Access Compliance Report

Public Rights-of-Way

(Curb Ramps)

Intersection ID: 17009	Main Street: N_WENDOVER_RD	Cross Street: RANDOLPH_RD	Location:	E
ADA ID: DF3C64BD5986	Ramp Type: Perp	Initial Pass/Fail: Fail	Overall Compliance: No	Severity Score: 10

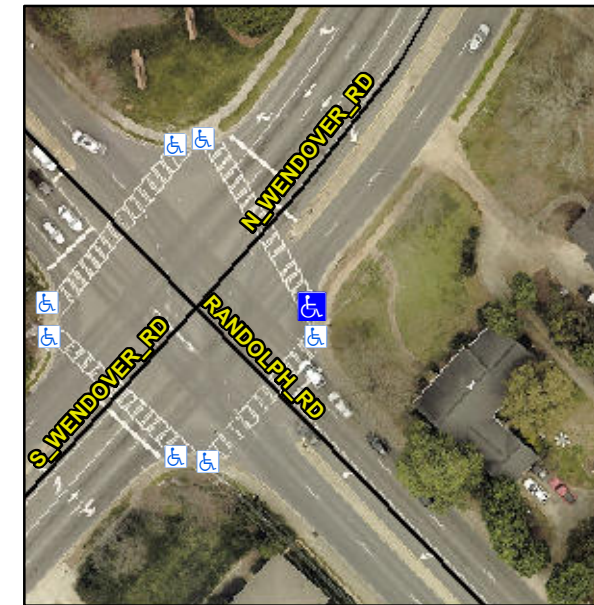
Not Found, R304.5.1, R304.5.3

Compliance	Description	Data	Compliance	Description	Data
N/A	Ramp Length (in)	89.0	Yes	Ramp Slope (%)	8.3
No	Ramp Width (in)	37.5	No	Ramp XSlope (%)	2.7
N/A	Flare Type LT	N/A	N/A	Flare Type RT	N/A
N/A	Flare Slope LT (%)	N/A	N/A	Flare Slope RT (%)	N/A
N/A	Flare Traversable LT?	N/A	N/A	Flare Traversable RT?	N/A
N/A	Landing Length (in)	N/A	N/A	DWS Provided?	N/A
N/A	Landing Width (in)	N/A	N/A	DWS Contrast?	N/A
N/A	Landing Slope (%)	N/A	N/A	DWS Length (in)	N/A
N/A	Landing X Slope (%)	N/A	N/A	DWS Full Width?	N/A
N/A	Landing Curb? (Y/N)	N/A	N/A	DWS Offset (in)	N/A
N/A	Shared Landing?	N/A			
N/A	Gutter Ponding?	N/A	N/A	Gutter Slope (%)	N/A
N/A	Gutter Lip Ht (in)	N/A	N/A	Gutter X Slope (%)	N/A
N/A	Painted X Walk1?	Yes	N/A	Painted X Walk2?	N/A
	X Walk 1 Direction	To NW		X Walk 2 Direction	N/A
N/A	X Walk 1 Width (in)	109.0	N/A	X Walk 2 Width (in)	N/A
	X Walk 1 Slope (%)	1.4		X Walk 2 Slope (%)	N/A
	X Walk 1 X Slope (%)	0.9		X Walk 2 X Slope (%)	N/A

Remove & Replace Entire Ramp.
